**GENOA CHARTER TOWNSHIP
PLANNING COMMISSION
SPECIAL MEETING AND PUBLIC HEARING
JANUARY 9, 2024
TUESDAY
6:30 P.M.
AGENDA**

OPEN PUBLIC HEARING #1...Consideration of a sketch plan application and sketch plan for façade revisions to the existing Dave's Hot Chicken Restaurant located at 3667 E. Grand River Avenue, north side of Grand River Avenue, west of Latson Road. The request is petitioned by Sarah Goeke, Owners Agent.

Attention:	Amy Ruthig, Planning Director
Subject:	Dave’s Hot Chicken – Sketch Plan Review #1
Location:	3667 E. Grand River Avenue – north side of Grand River, west of Latson Road
Zoning:	RCD Regional Commercial District

PROPOSED ELEVATION
RECEIVED 12-7-23

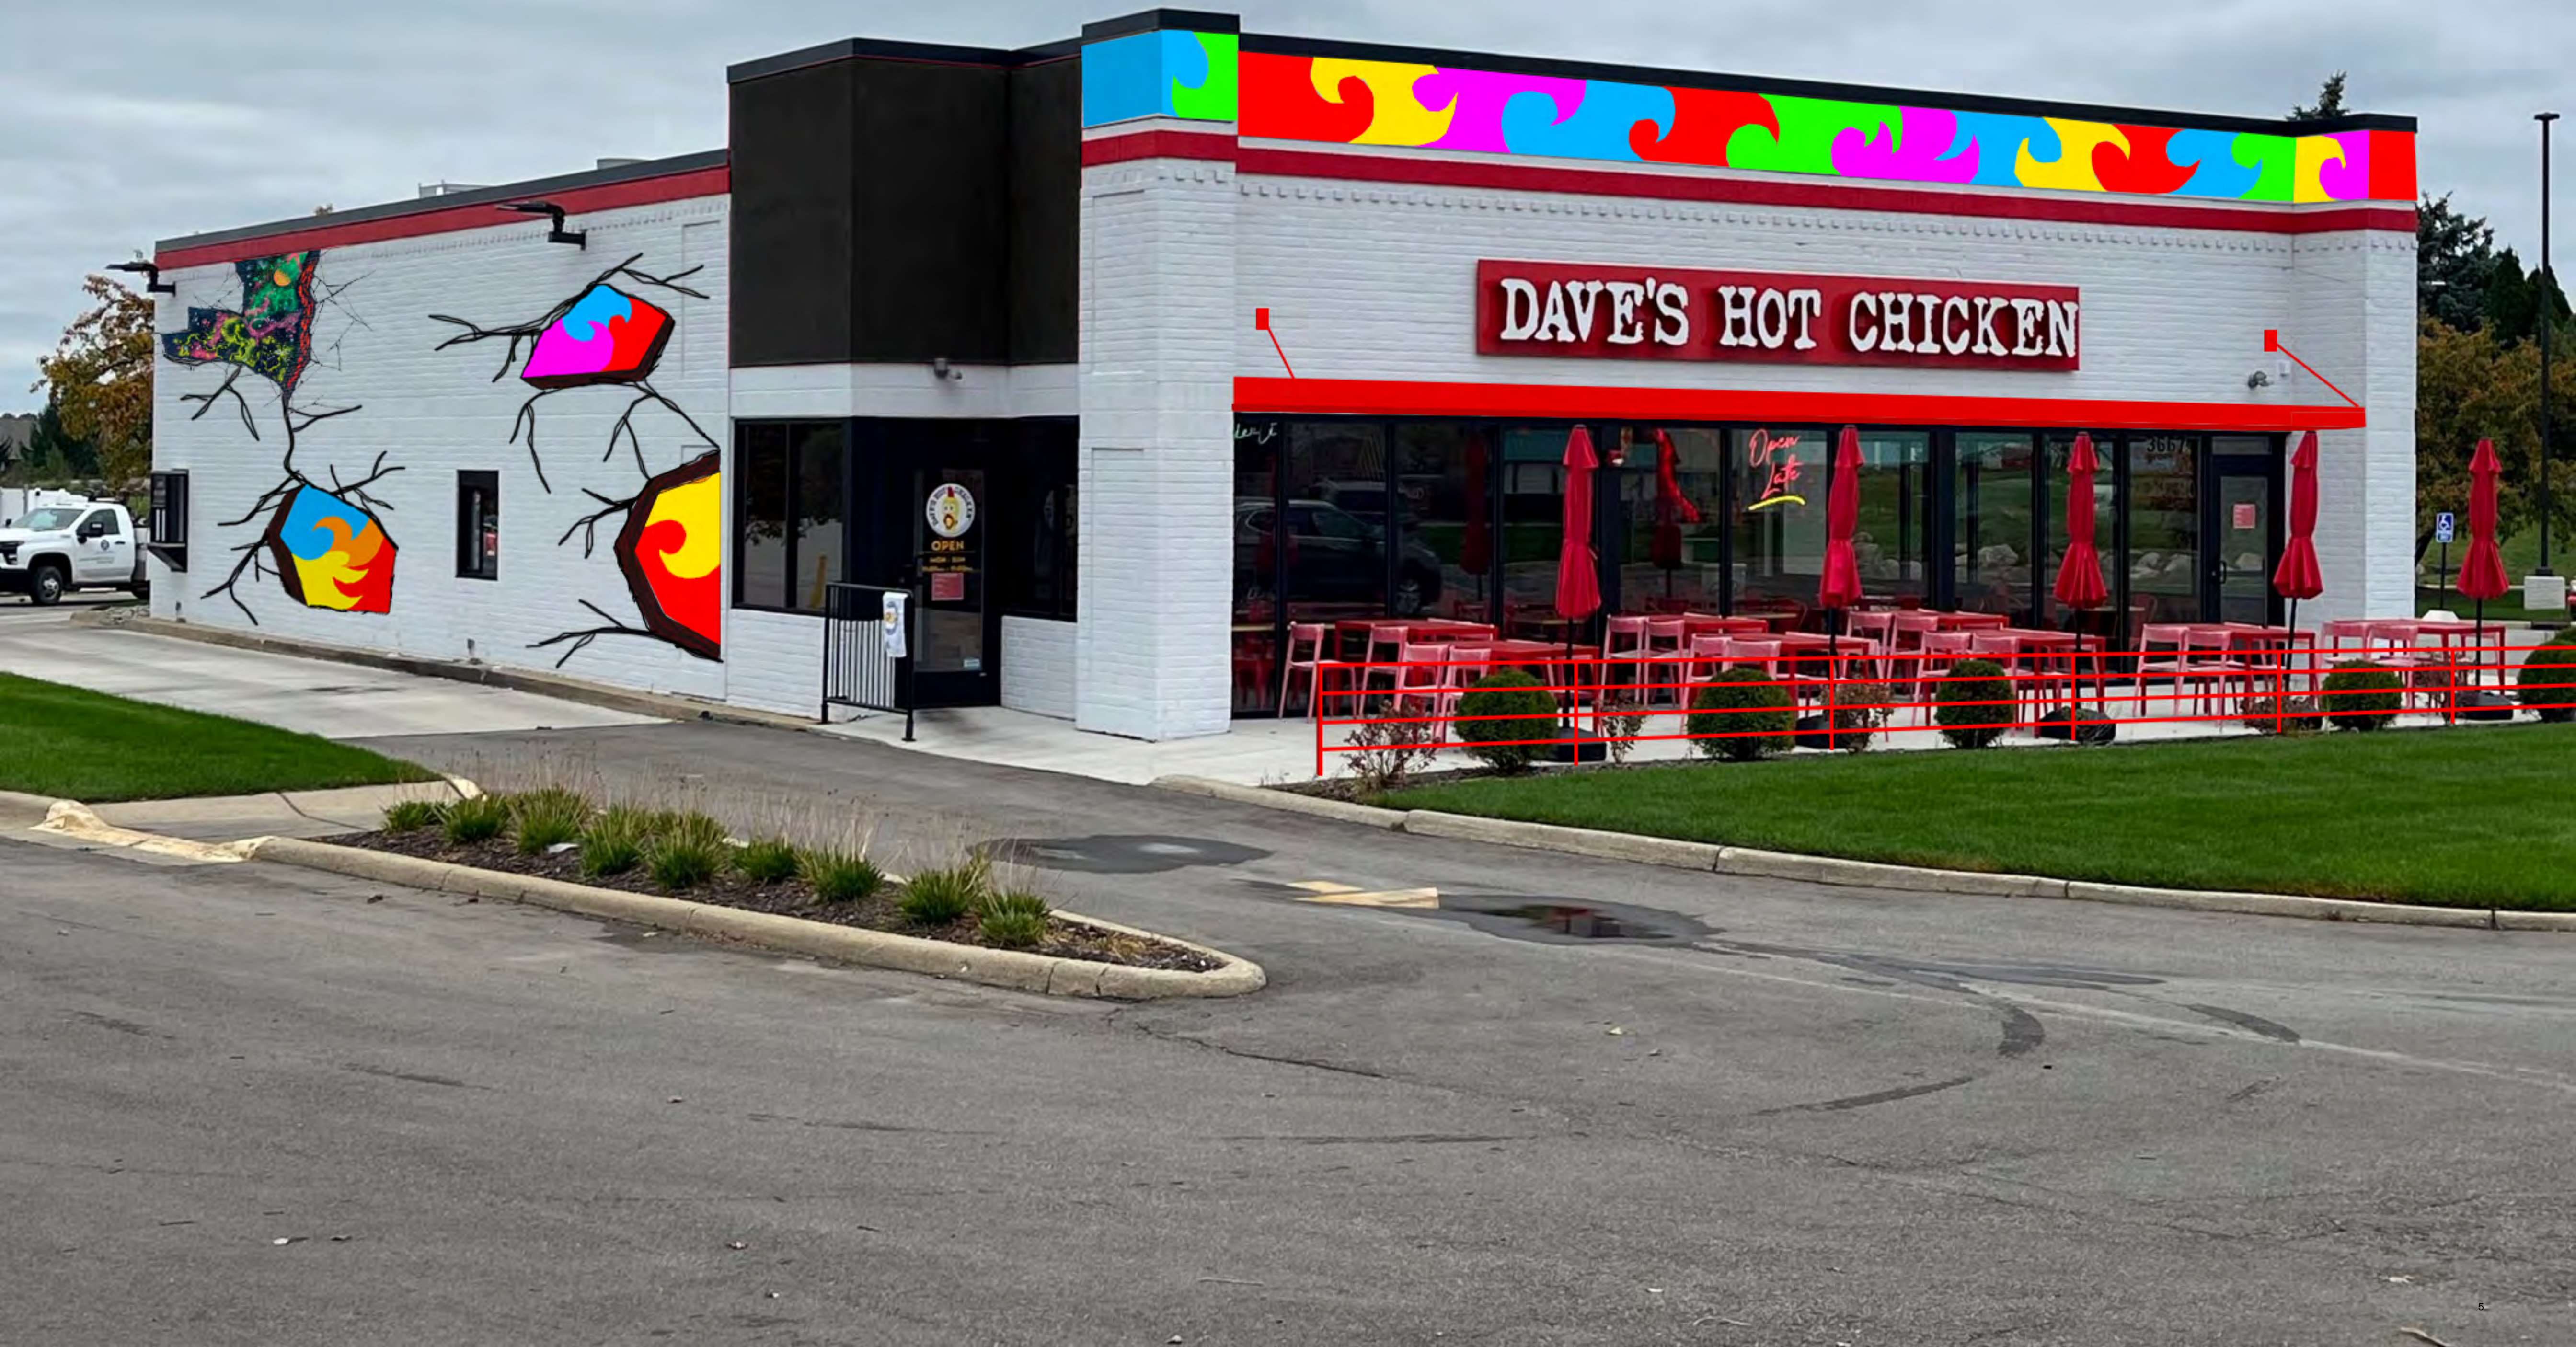
1. The Planning Commission has review and approval authority over building materials and colors.
2. The applicant proposes the inclusion of multiple bright colors on the mainly white and red building.
3. We request the applicant confirm that no changes to building materials are proposed (or provide additional details).
4. We request the applicant confirm that the changes are only proposed to the front and west side of the building (or provide additional details).
5. Section 12.01.05 requires that building colors “relate well and be harmonious with the surrounding area” and that “subtle earth tone colors shall be used.”
6. In our opinion, the proposed façade changes do not meet the requirements of the Zoning Ordinance.

If similar changes are also proposed to the east side and/or rear of the building, the applicant must provide details for the Commission's consideration.
